ADDENDUM NO. 1

TO: PLANS AND SPECIFICATIONS FOR STATE OF MISSOURI

**Sewer and Water Line Improvements
Weston Bend State Park
Weston, Missouri
Project No. X2322-03**

Bid Opening Date: 1:30 PM, Tuesday, October 15, 2024 (Not Changed)

C-104

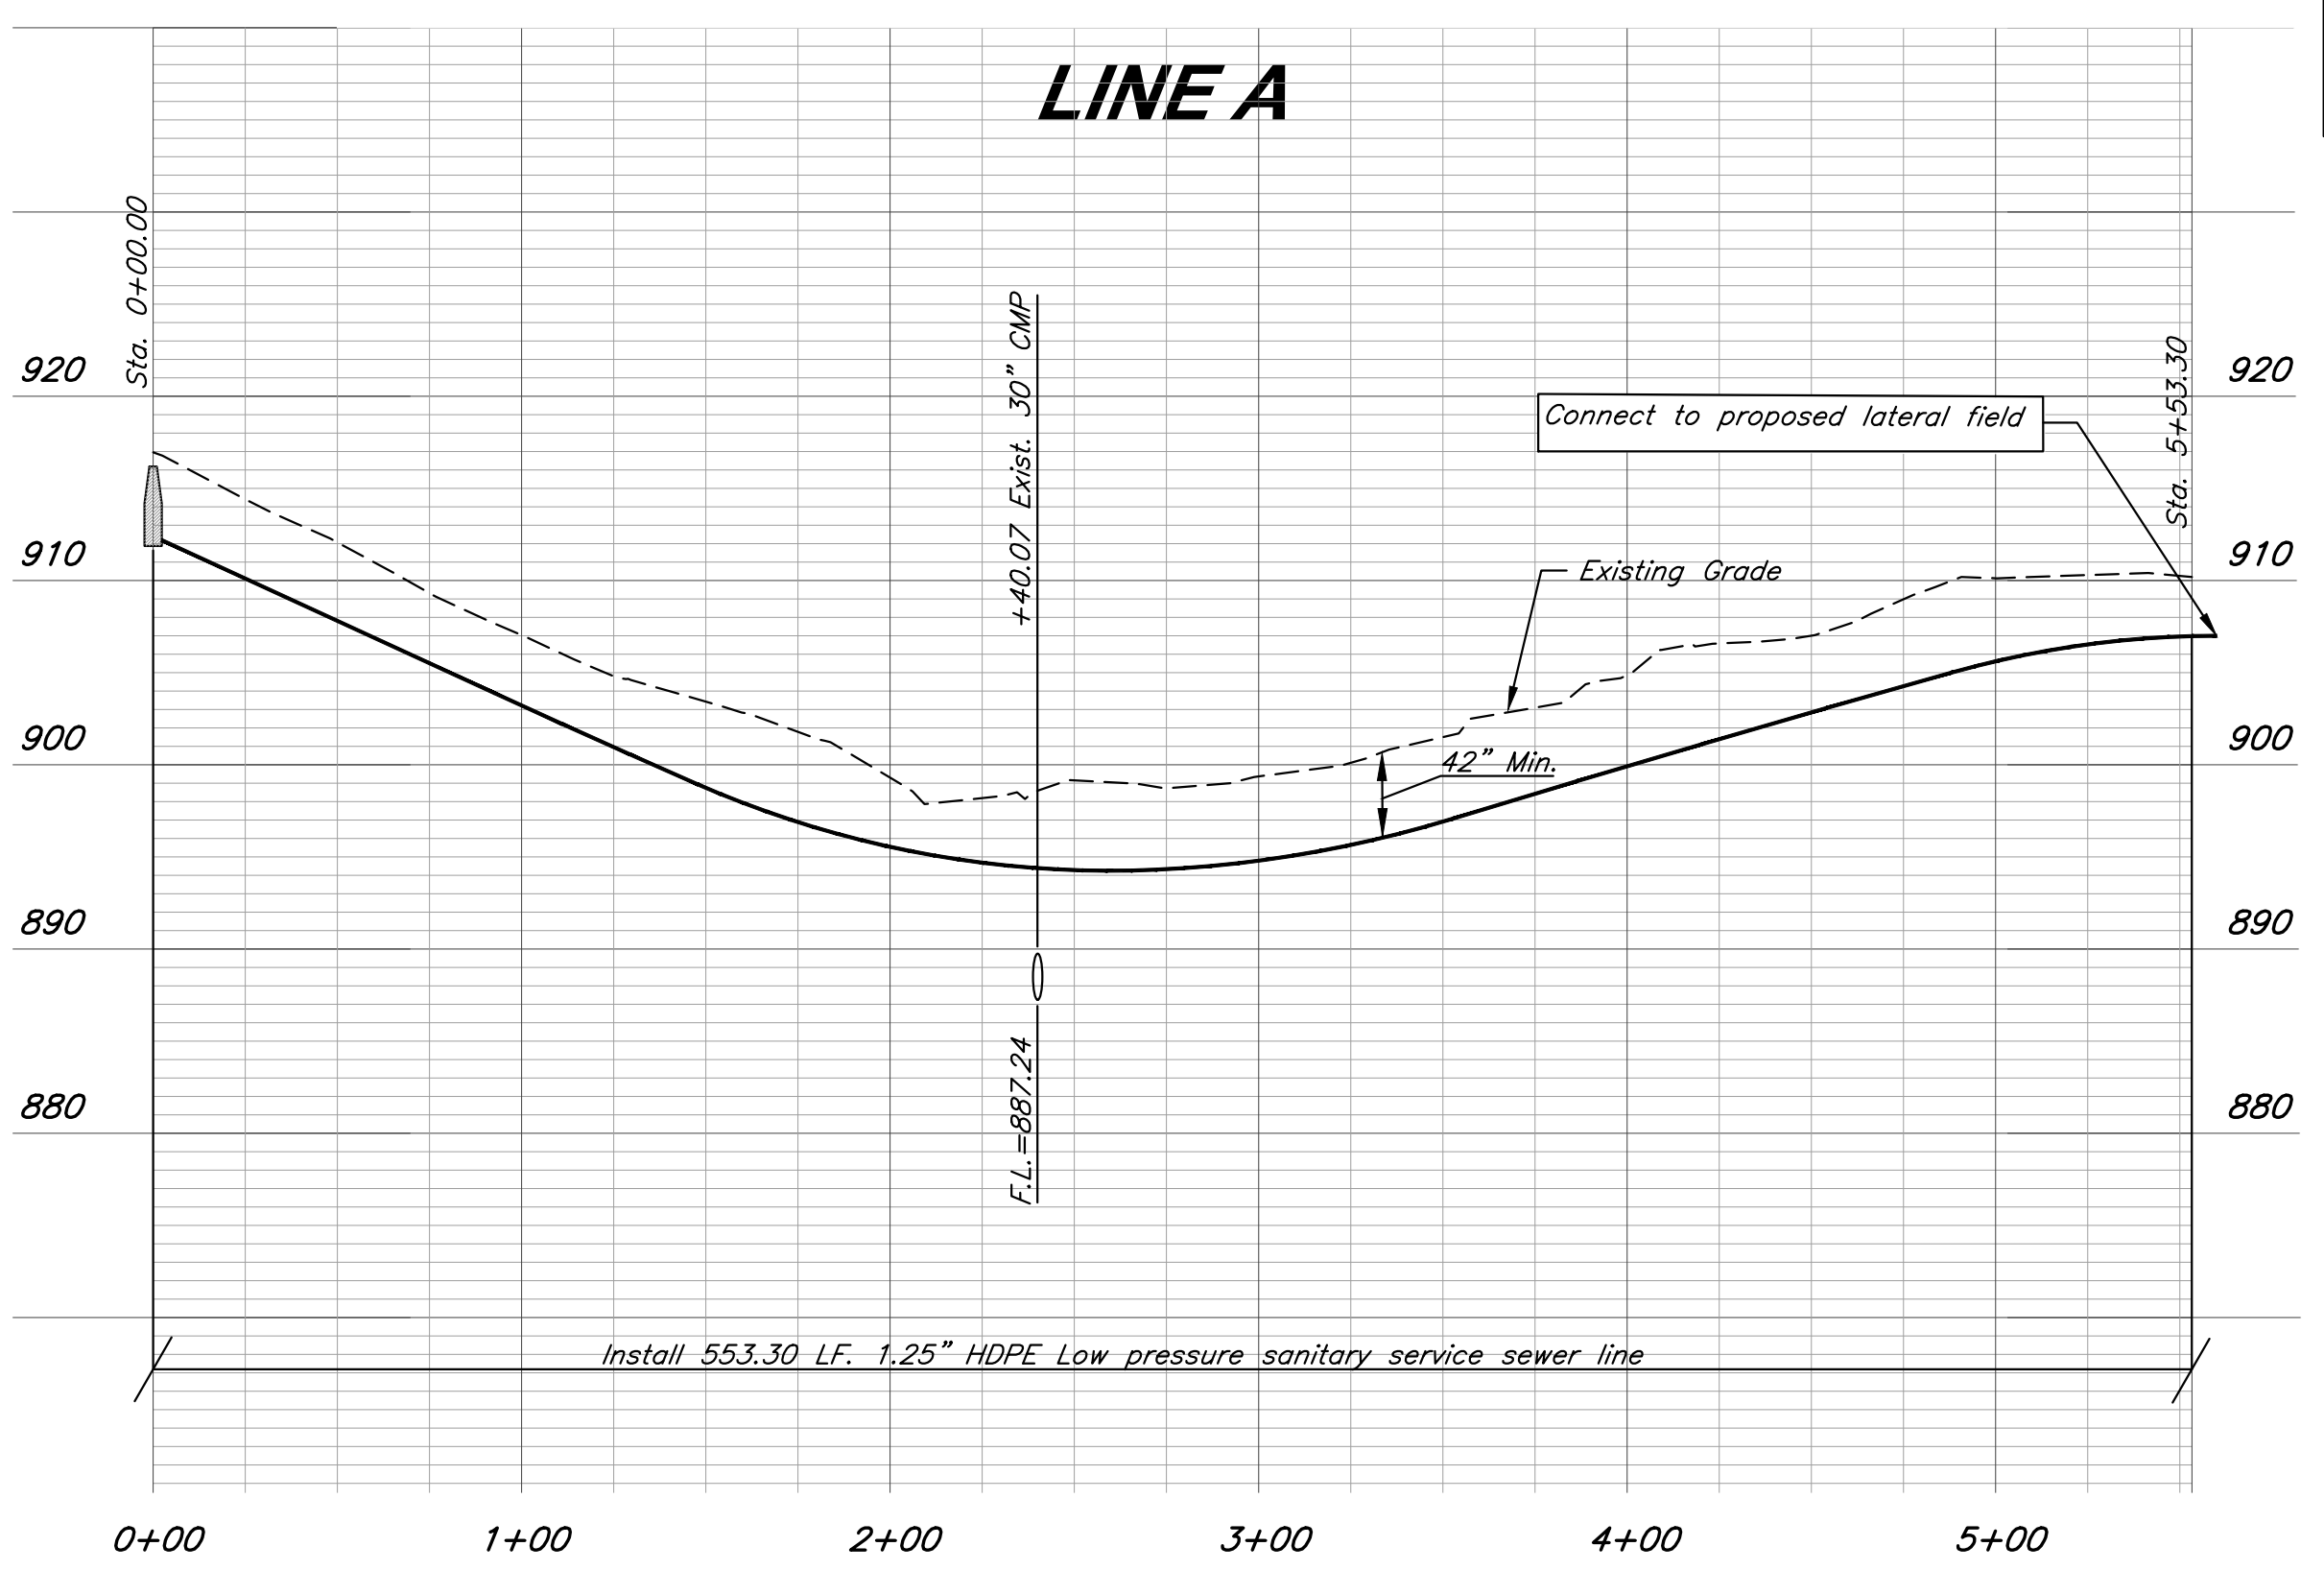
1. Sheet C-104
 - a. Add designation for septic and pump tanks.
 - b. Change MicroFAST 3.0 to MicroFAST 9.0 or equal AND increase size of tank S2 to 9,000 gal.

- c. Revise note for first tank (S1): "Replace existing septic tank w/ 4,000 gal. Septic Tank"
 - d. Remove Manhole A-2 and Host site connection. Replace with grinder pump and 1000 gal. pump tank. Add service line to Septic tank S-1

- e. Add enlargement 2 – Blow up of Grinder Pump servicing camp host site.
 - f. Add pump curve for effluent pump A-1 (pump to lateral field)
 - g. Add 535 LF of 1.25" HDPE line from camp host site to septic tank S1 (First septic tank).

- h. Add Lateral Field Detail to sheet.
 - i. Revise pump sizing calculation requirements. Add Pump Sizing calculations for Pump B-1.
 - j. Change profile effluent pipe size from 1" HDPE to 1.25" HDPE.

- k. Add note for secondary power connection: "A secondary power connection with power transfer switch for emergency power outages shall be provide for the A-1 and S-2 systems. Secondary connection is anticipated small portable gas/diesel generator. Generator shall provide power for entire system: Pumps, blowers, alarms, and another apparatus. Anticipated generator size is 2.5KW."

- l. See attached revised sheet for revisions.
2. Sheet C-105
 - a. ADD the following Note: "Install gate valves on main service line every 1,00 feet and at Tee connections."

- A-1 Pump Sizing**
- Static Head = -5 FT
 - Friction Loss = 553.3 FT of 1.25" HDPE at 25 gpm = 177.5 FT
Total = 178 FT
 - Total Dynamic Head = -5 + 178 = 173 FT
 - Pump Requirements: 25 gpm and 173 FT TDH

- B-1 Pump Sizing**
- Static Head = 5 FT
 - Friction Loss = 535 FT of 1.25" HDPE at 13 gpm = 47.6 FT
Total = 48 FT
 - Total Dynamic Head = 5 + 47 = 53 FT
 - Pump Requirements: 13 gpm and 53 FT TDH

A secondary power connection with power transfer switch for emergency power outages shall be provide for the A-1 and S-2 systems. Secondary connection is anticipated small portable gas/diesel generator. Generator shall provide power for entire system: Pumps, blowers, alarms, and another apparatus. Anticipated generator size is 2.5KW

- REQUIREMENTS**
- Minimum area of 1,700 ft².
 - 340 LF of dispersal tubing placed 5 ft. O.C.
 - 4 Lengths at 85'.
 - Dispersal tubing shall be installed at 24" below finished grade. See Detail this sheet.
 - Contractor to pump out and remove existing septic tanks.

C-106

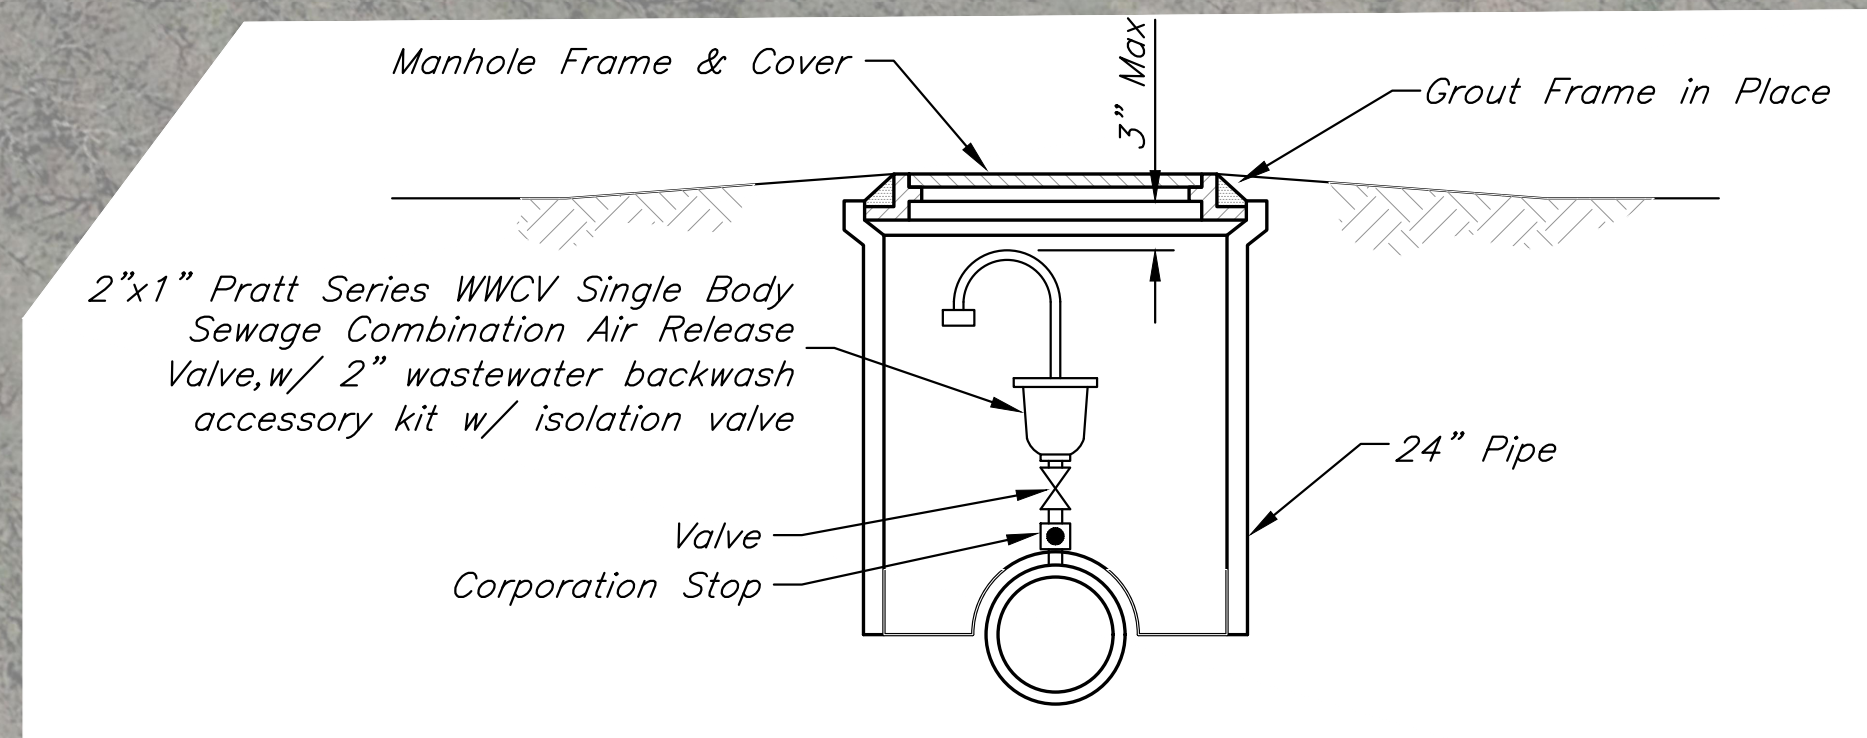
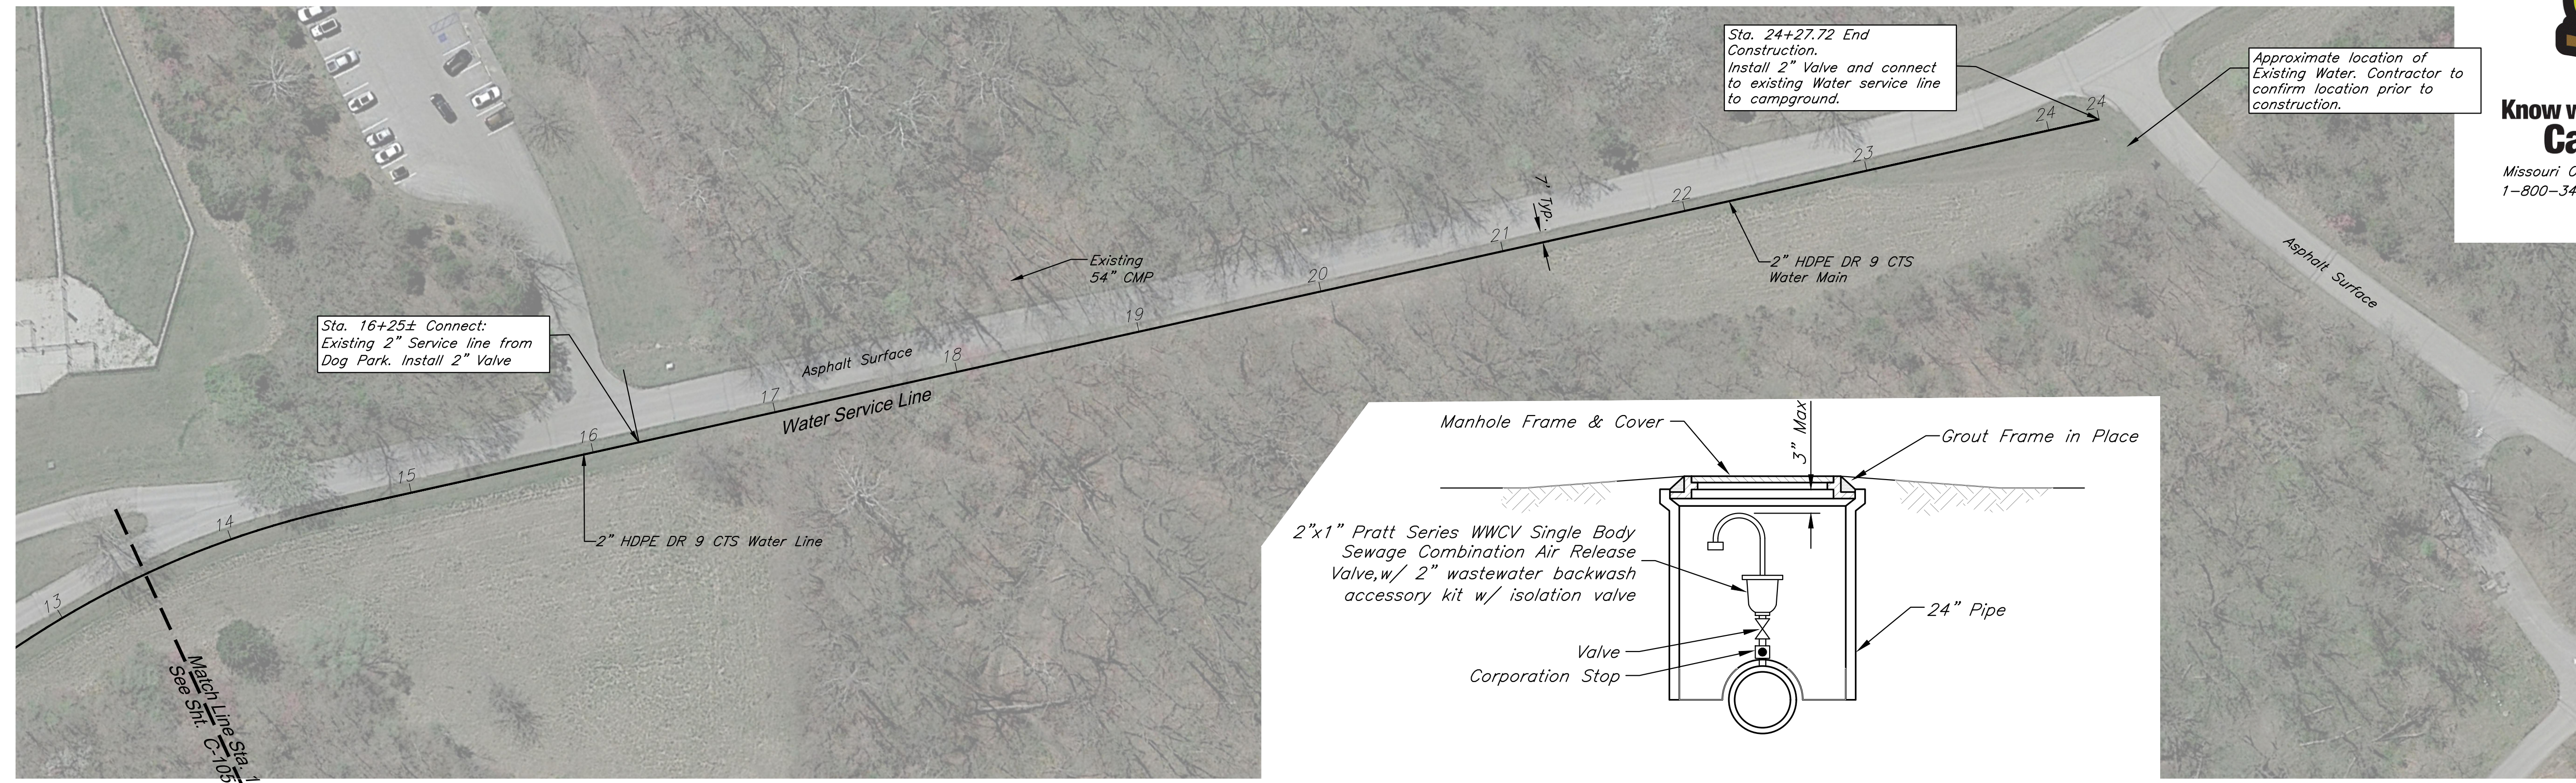
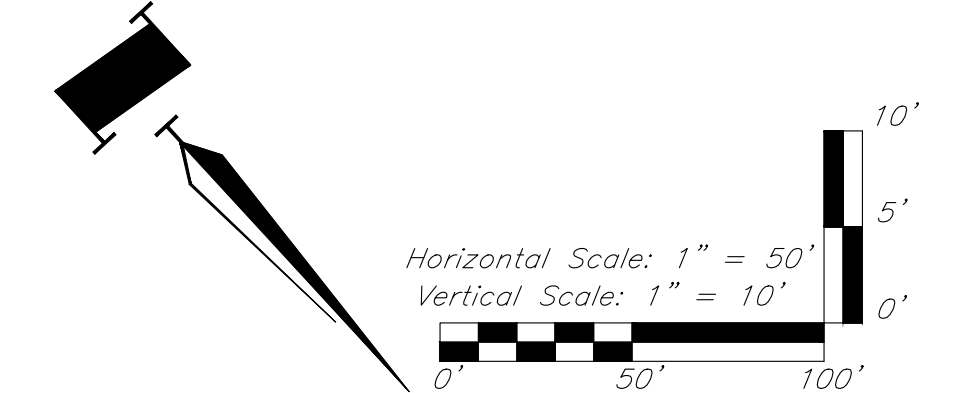
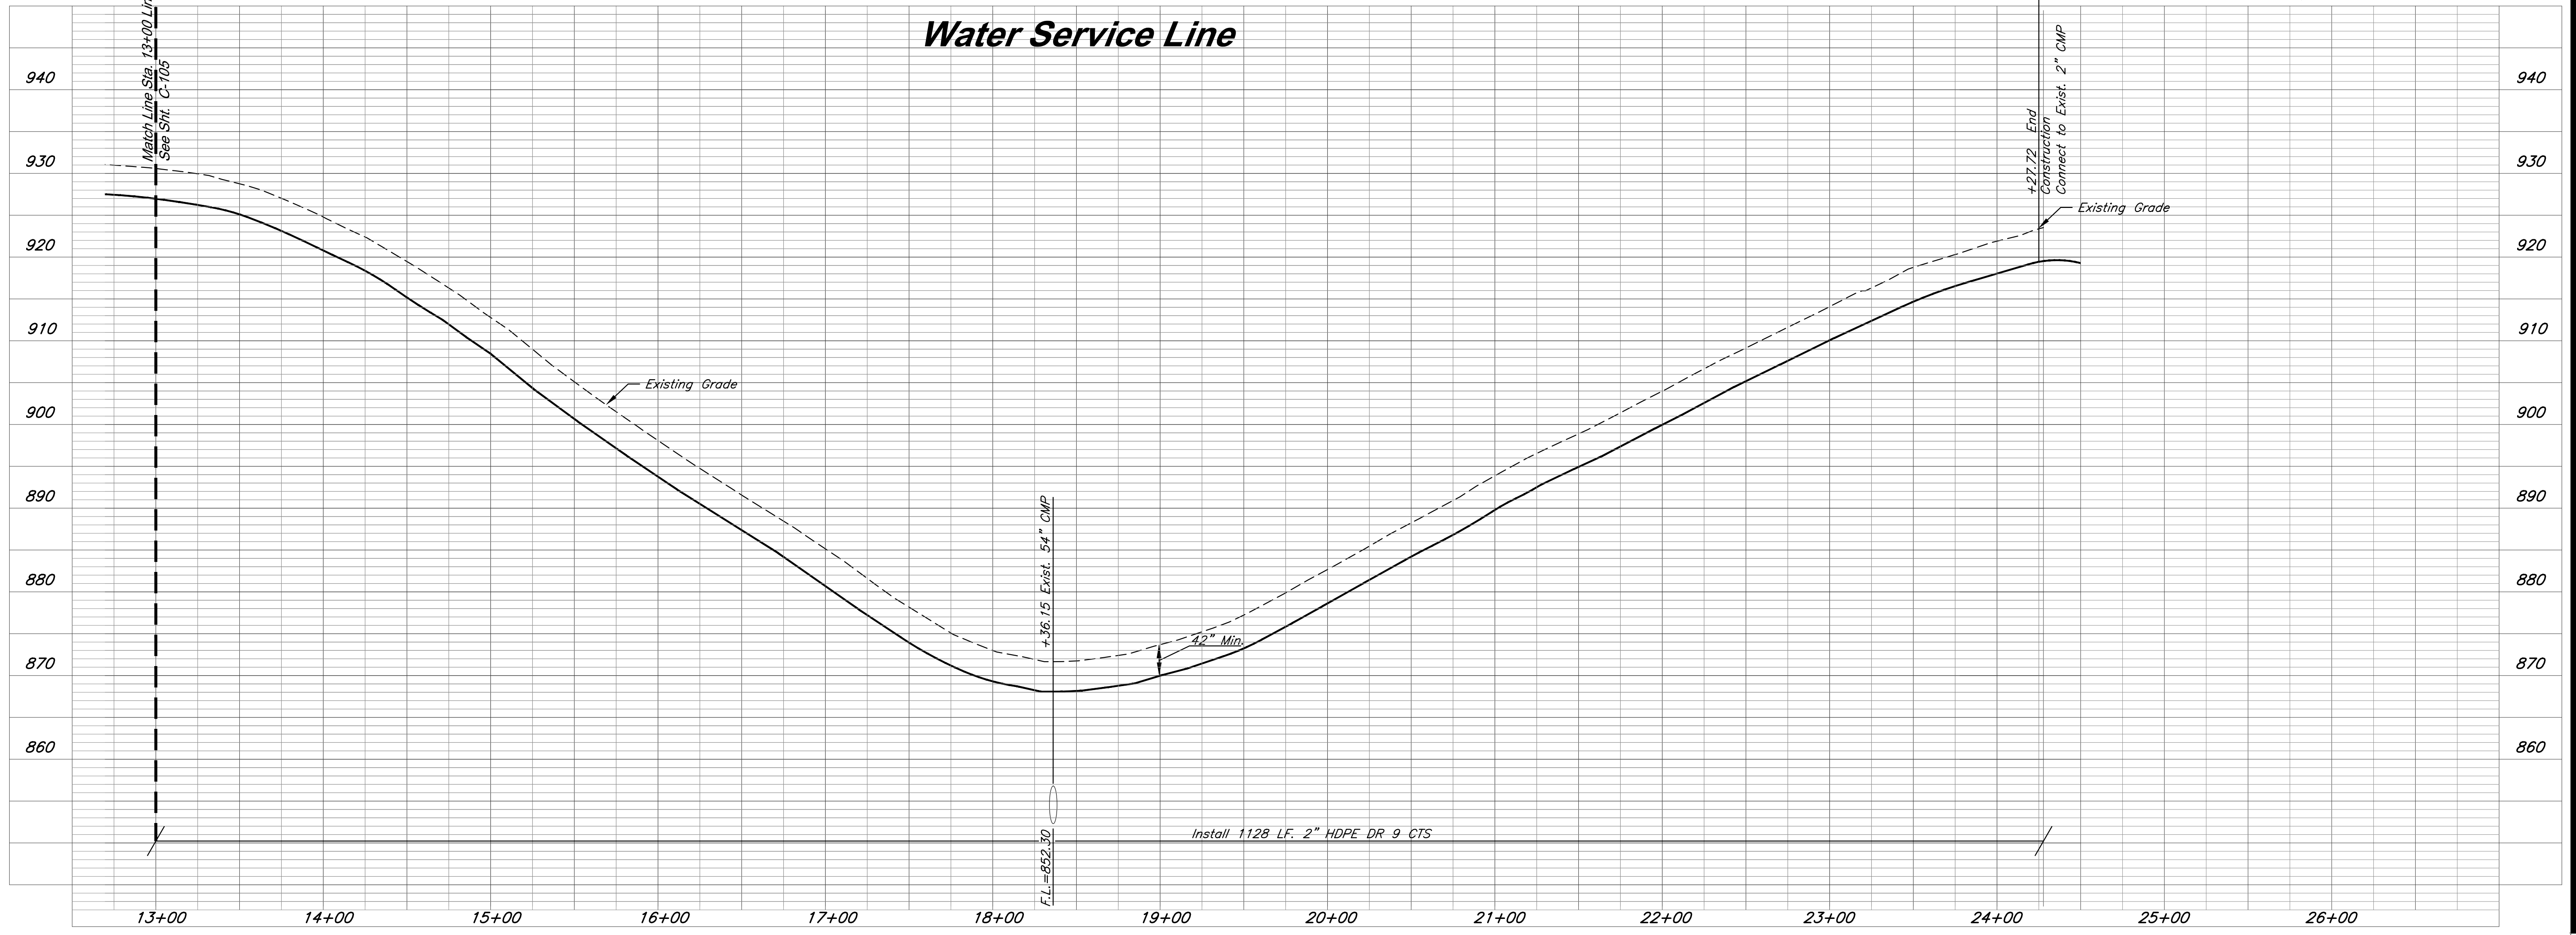
3. Sheet C-106
 - a. Add Air Release Valve to sheet.
 - b. Change EOL to connect into existing 2" line servicing campground at STA. 24+27.72
 - c. See attached revised sheet for revisions.
4. Sheet C-107
 - a. Remove manhole and air release valve details.
 - b. Add Grinder Pump detail.
 - c. Add SaniTEE detail.
 - d. Add MicroFAST 9.0 detail.
 - e. Add 4,000 gal Septic Tank detail.
 - f. See attached revised sheet for revisions.

AIR RELEASE VALVE
